BID Addendum-01

Project No.
JCDT23-0185

Title
Bid Clarification 01

Project Name
St Clair County Heath Dept Relocation

VAV BOX & PERIMETER HEATING CEILING PANEL SEQUENCE OF OPERATION:

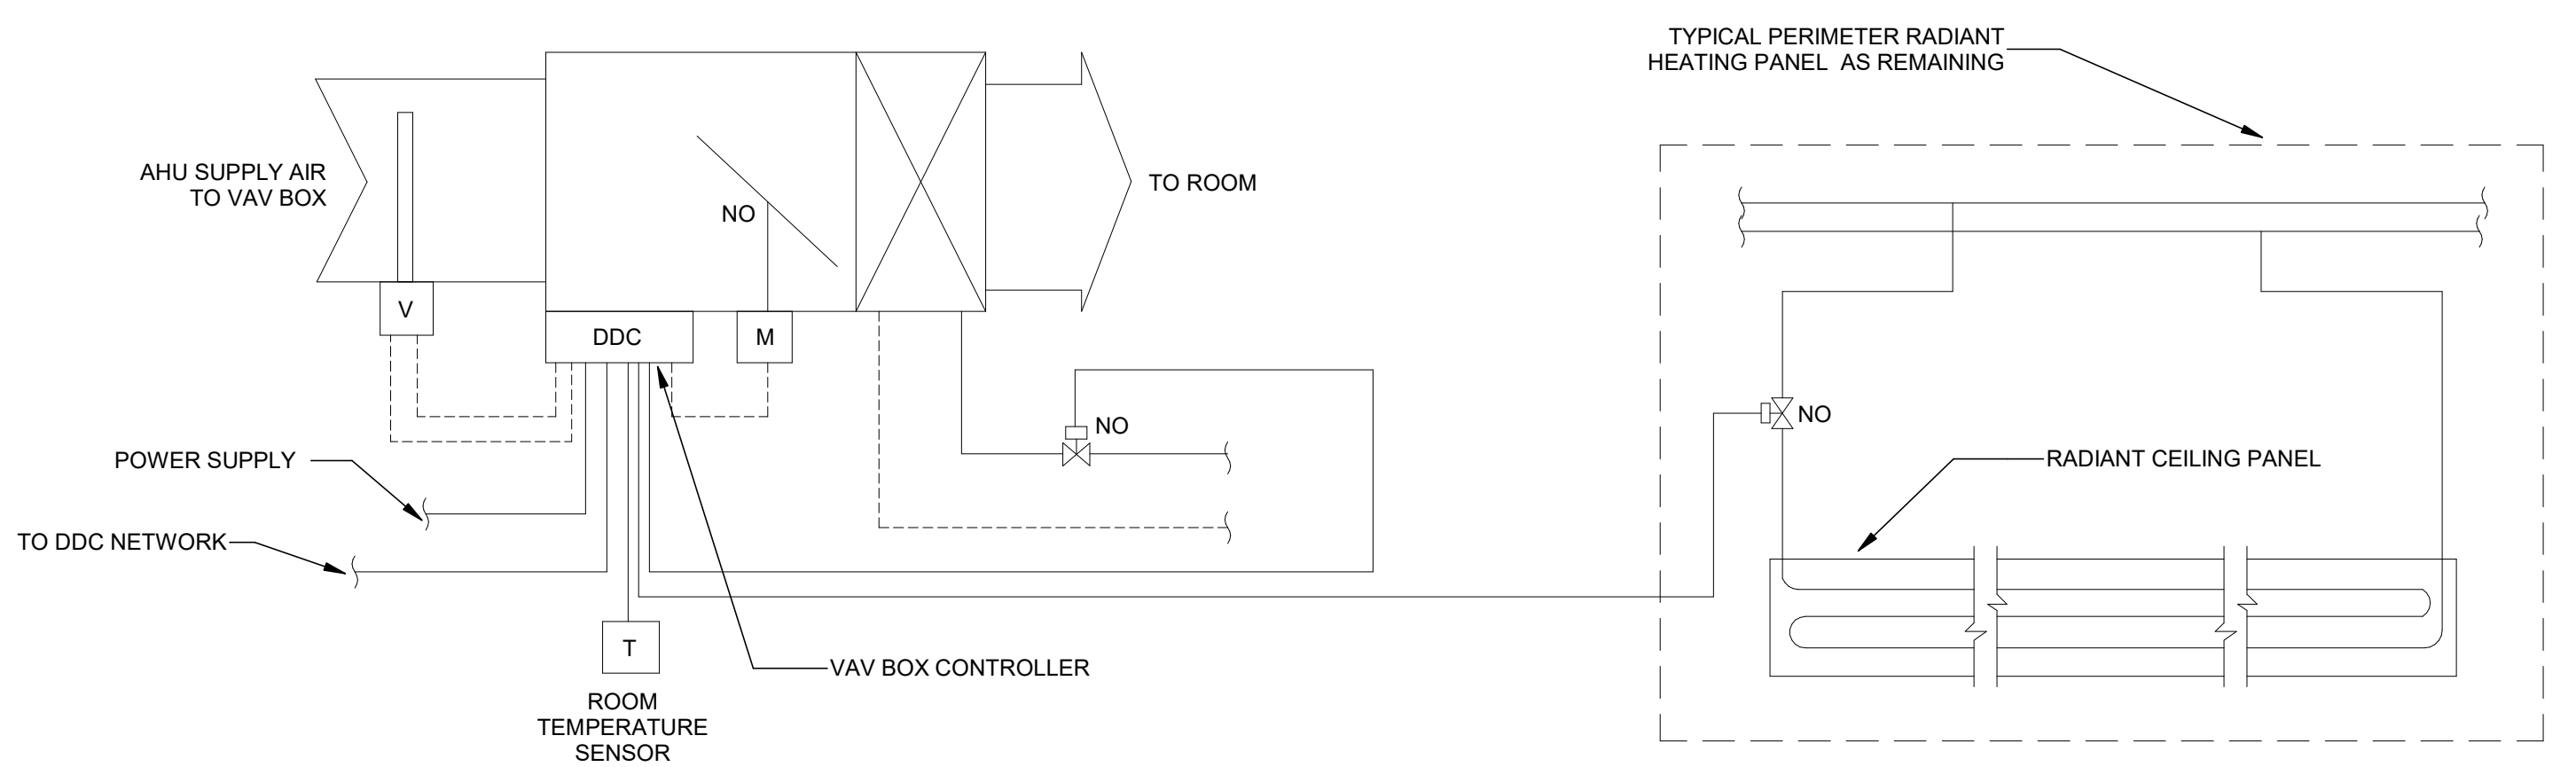
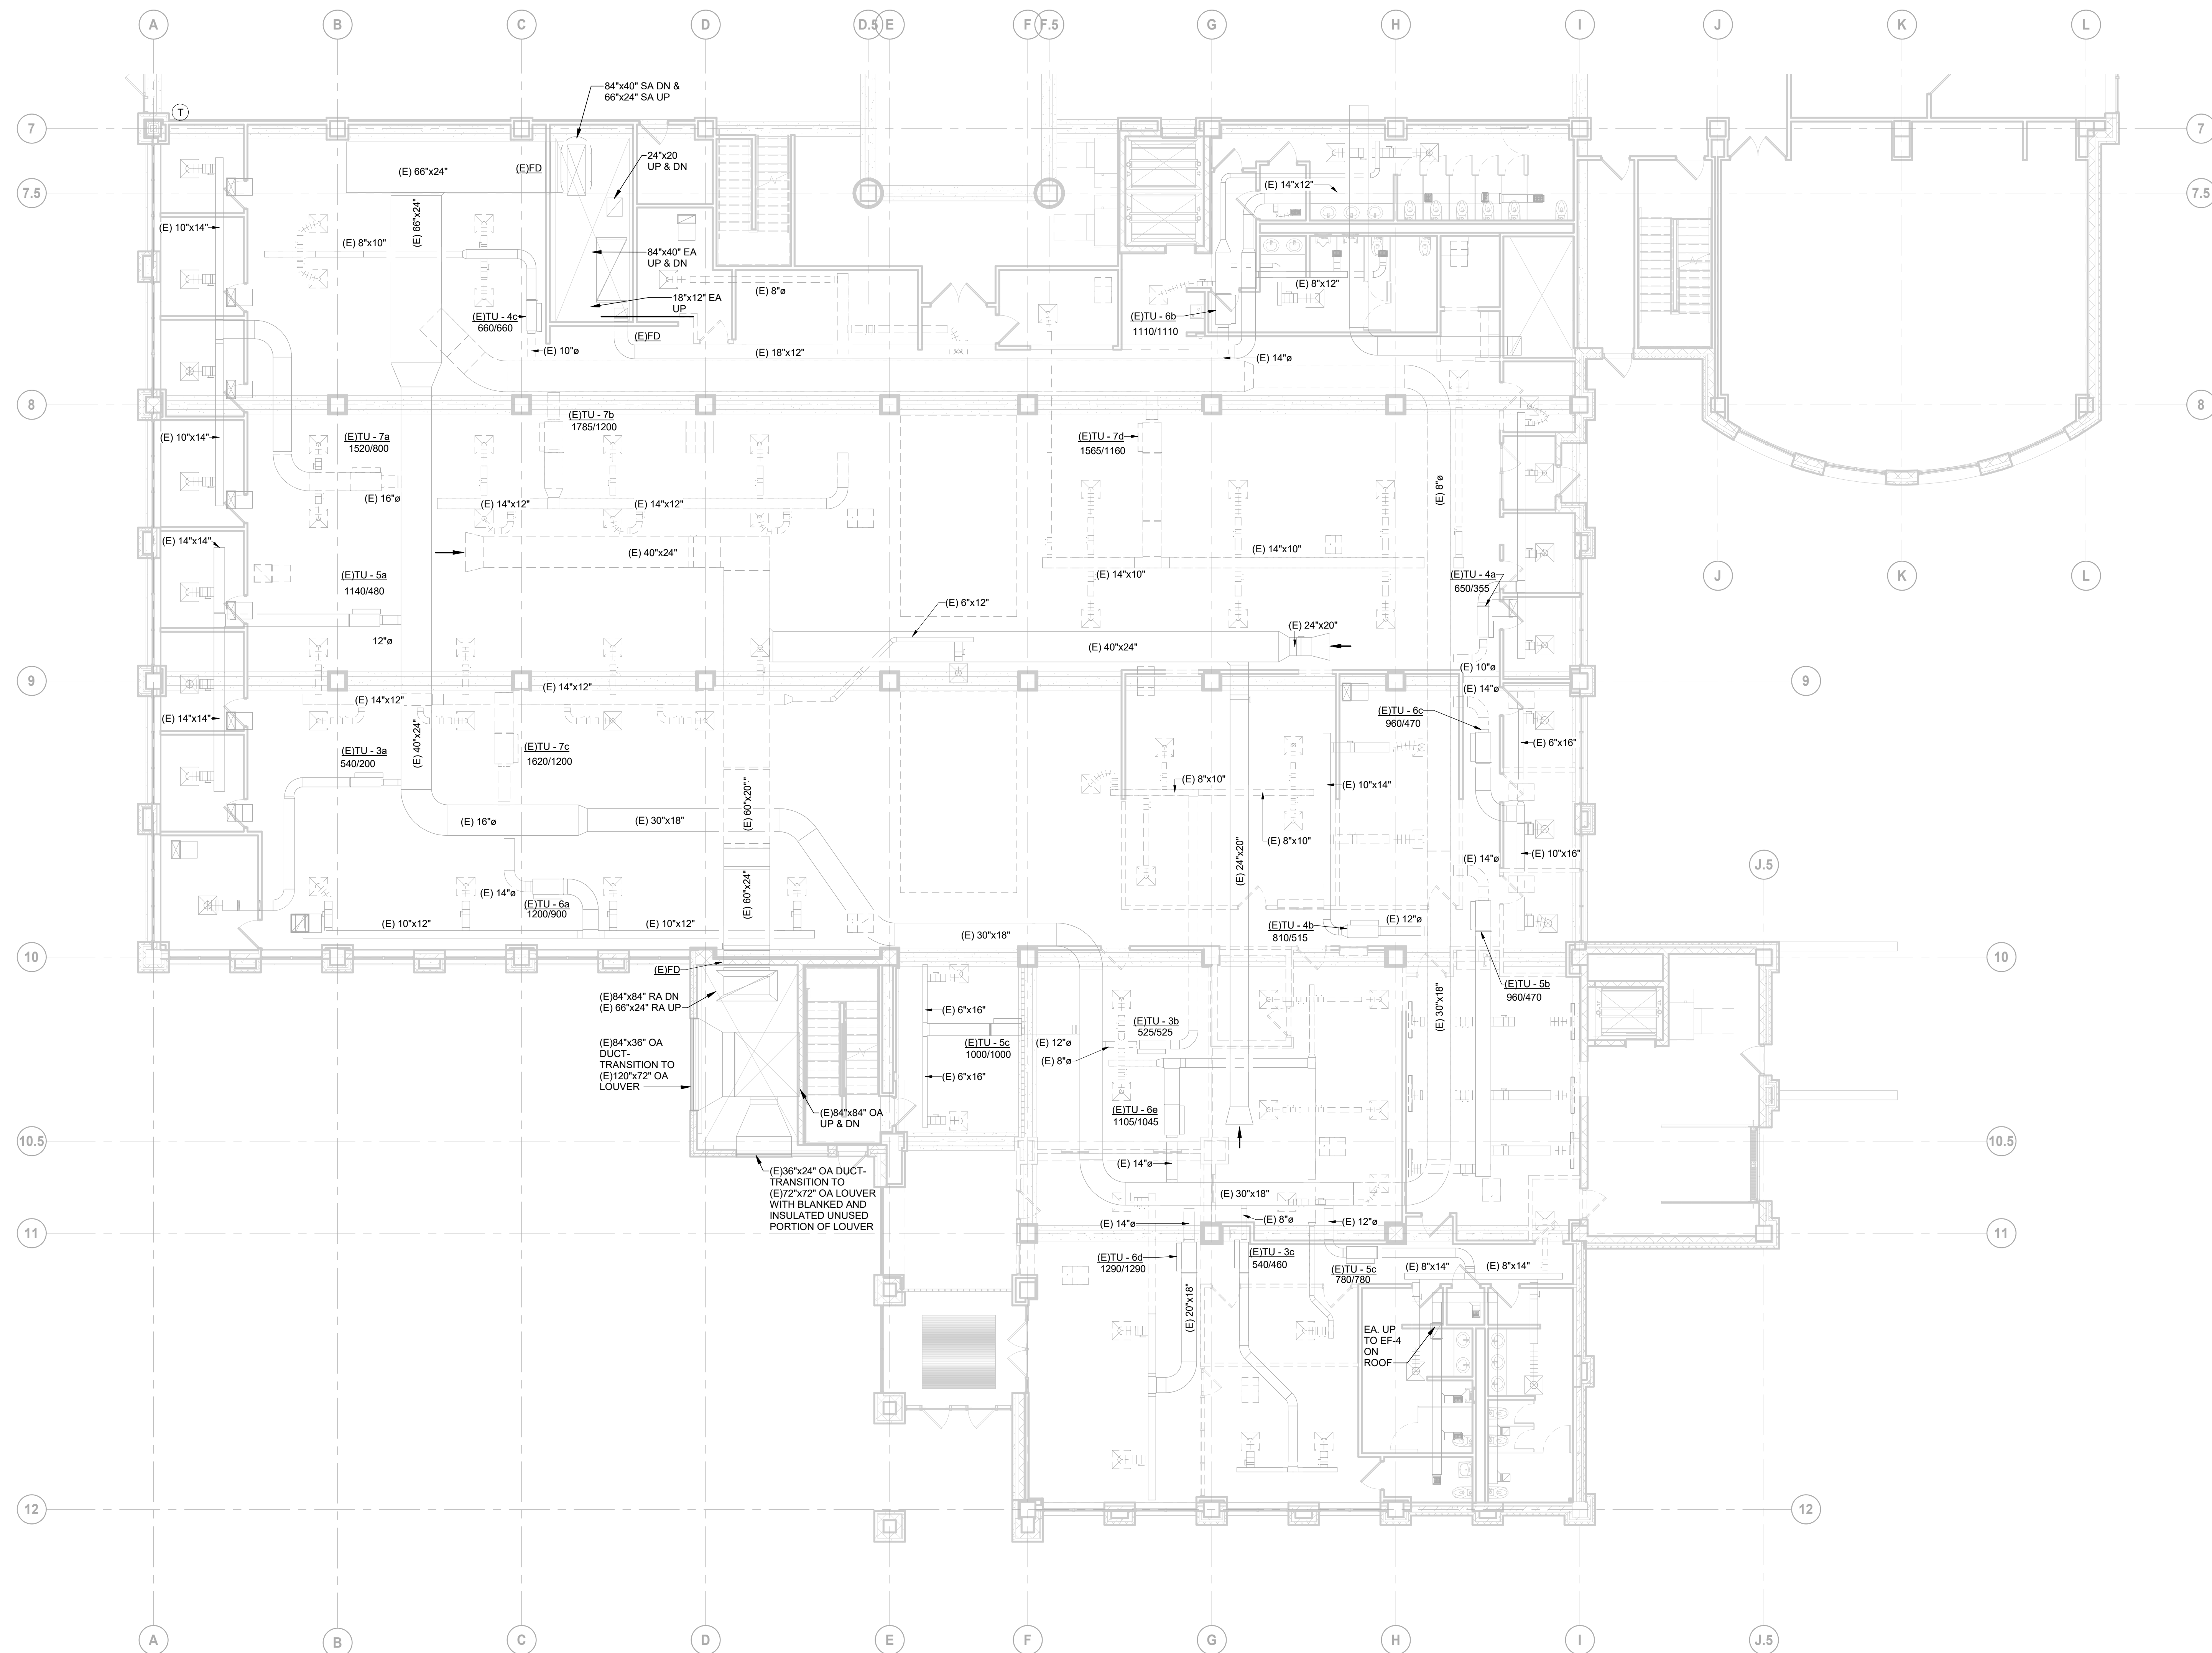
16. Dwg No M60-02
 - a. Added sheet with VAV box and perimeter heating ceiling panel control panel
 - b. Added control diagrams: Typical Constant Air Volume Terminals, Typical Variable Air Volume Terminal with Electric Reheat, Isolation Room Exhaust Fan, Needle Room Exhaust Fan, and Lab Constant Air Volume Terminal and Exhaust Fan Control Diagram.

1 SOUTH WING - LEVEL 2 HVAC DEMOLITION PLAN
SCALE: 1/8" = 1'-0"

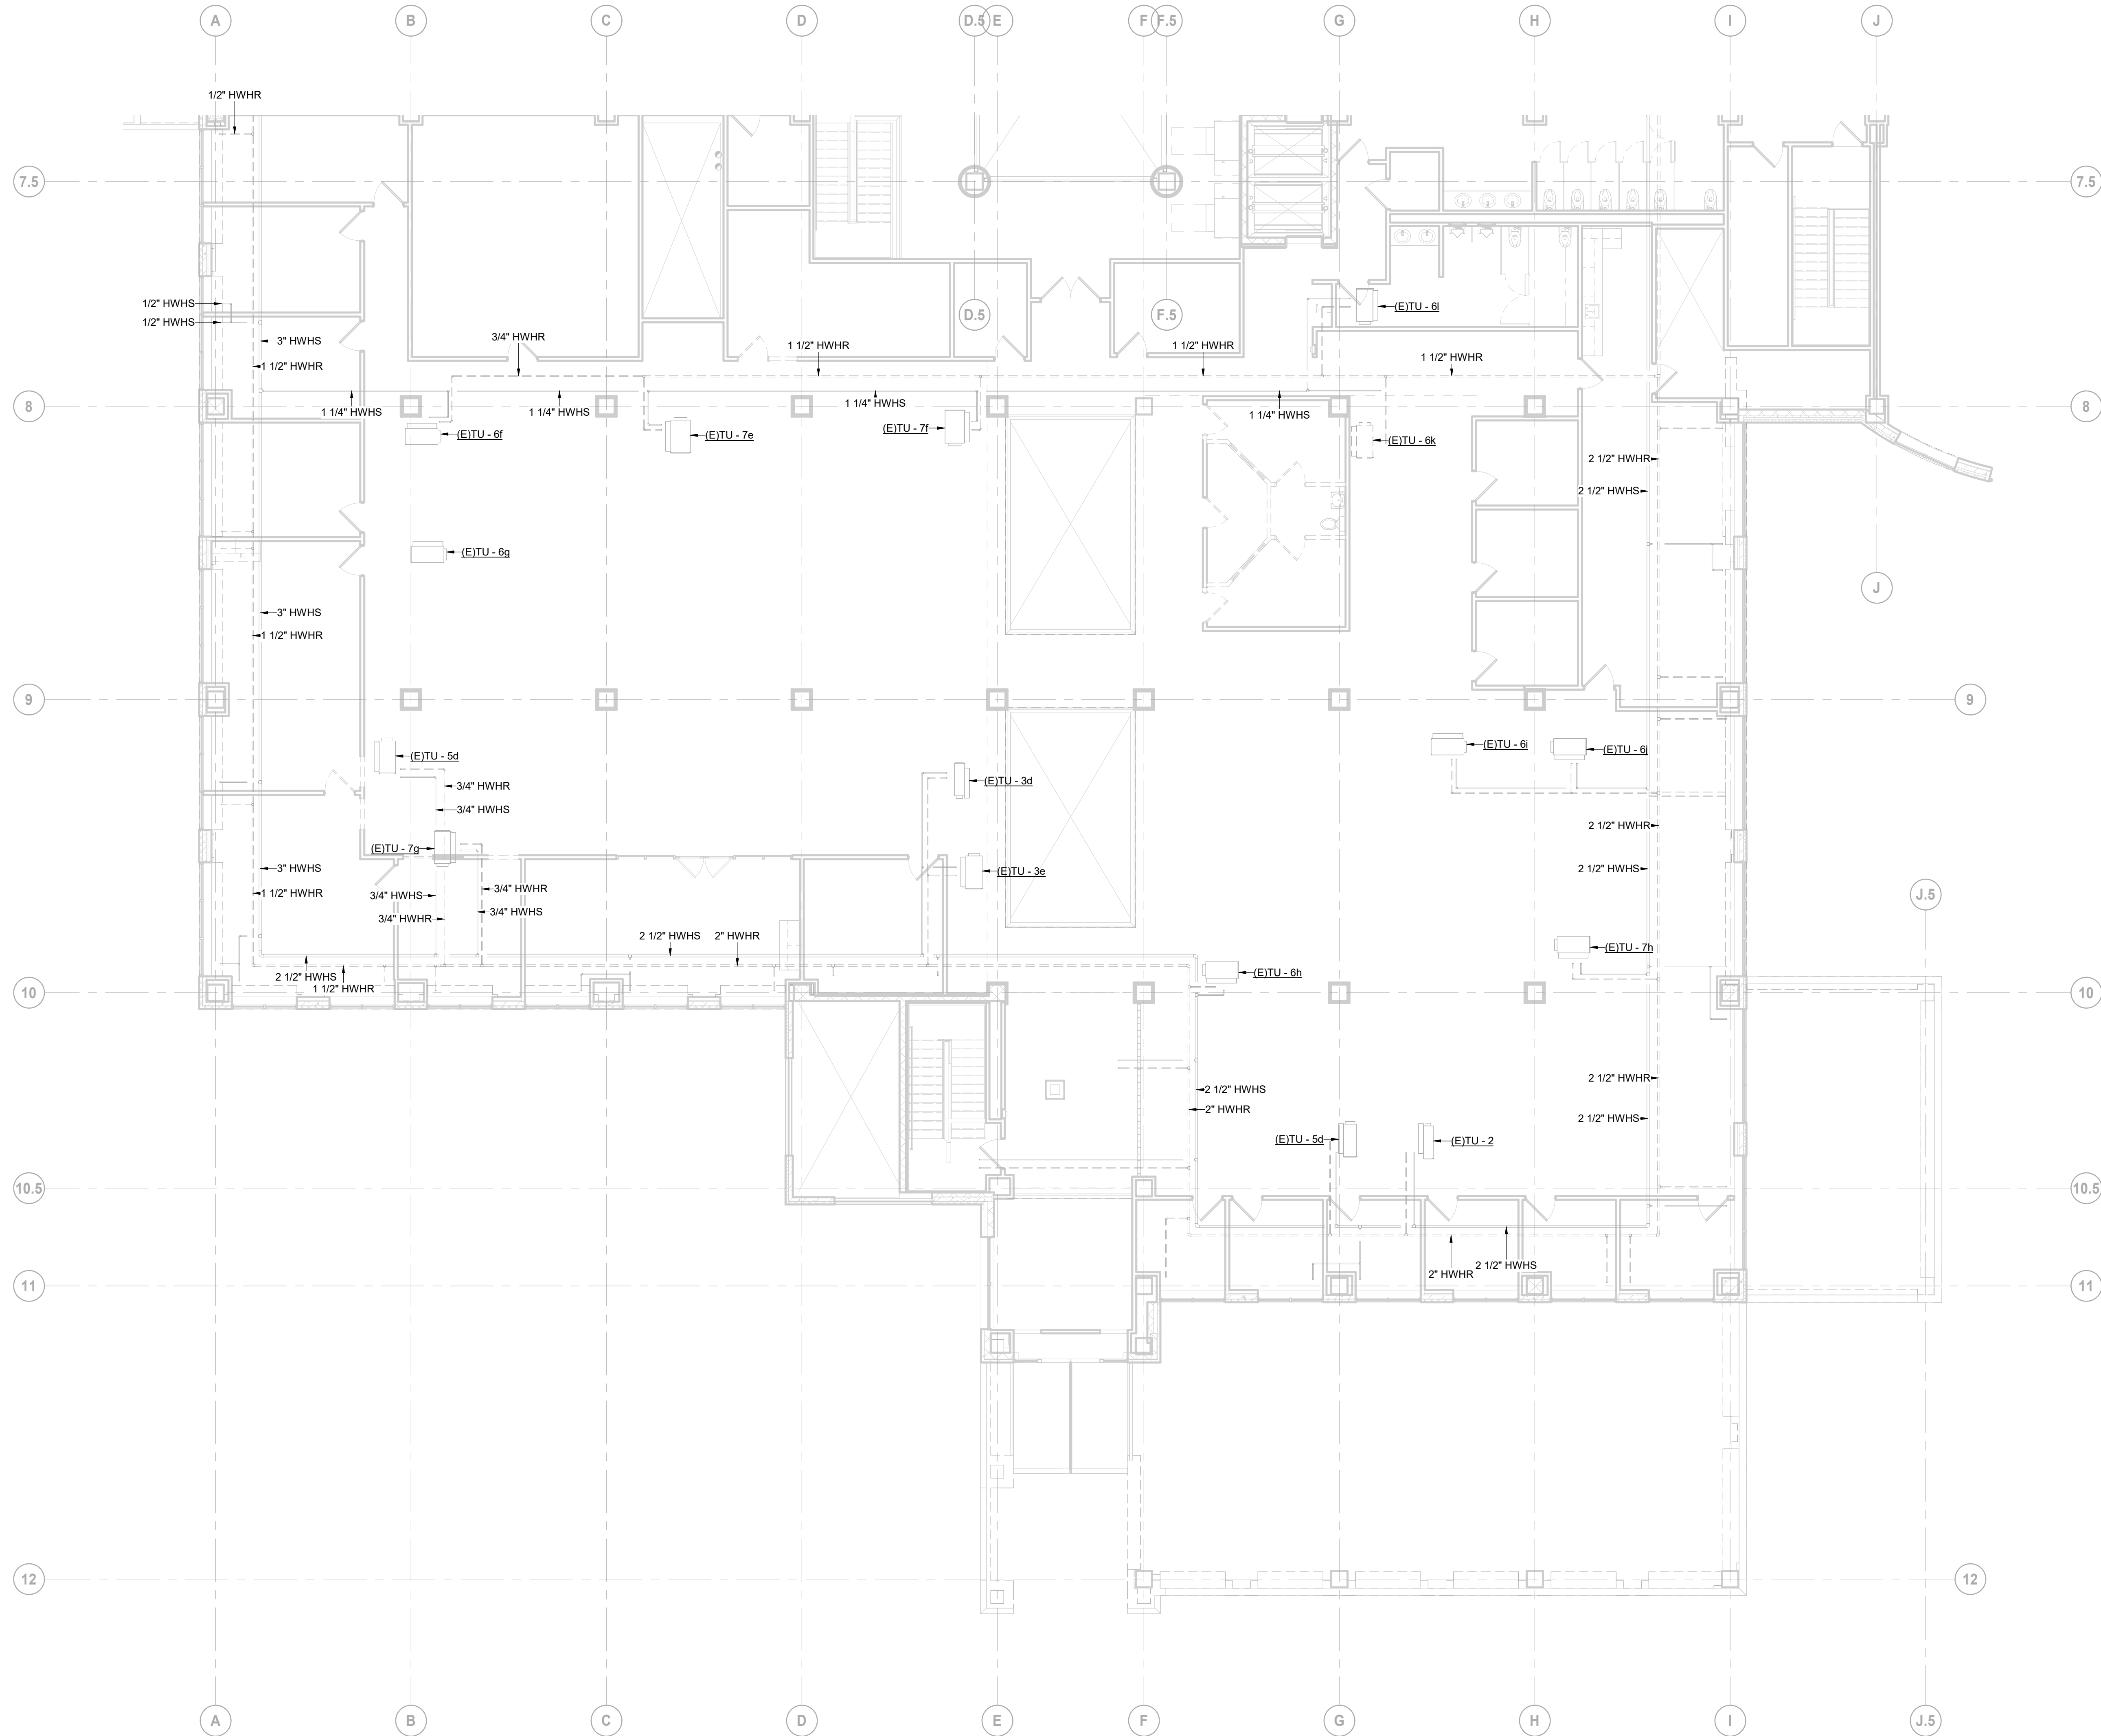
19. Dwg No M80-13
 - a. Supply duct in shaft has been relocated within the shaft to avoid interference.
20. Dwg No P00-03
 - a. Updated details and added new humidifier installation detail. Removed detail for the manifold in the duct.
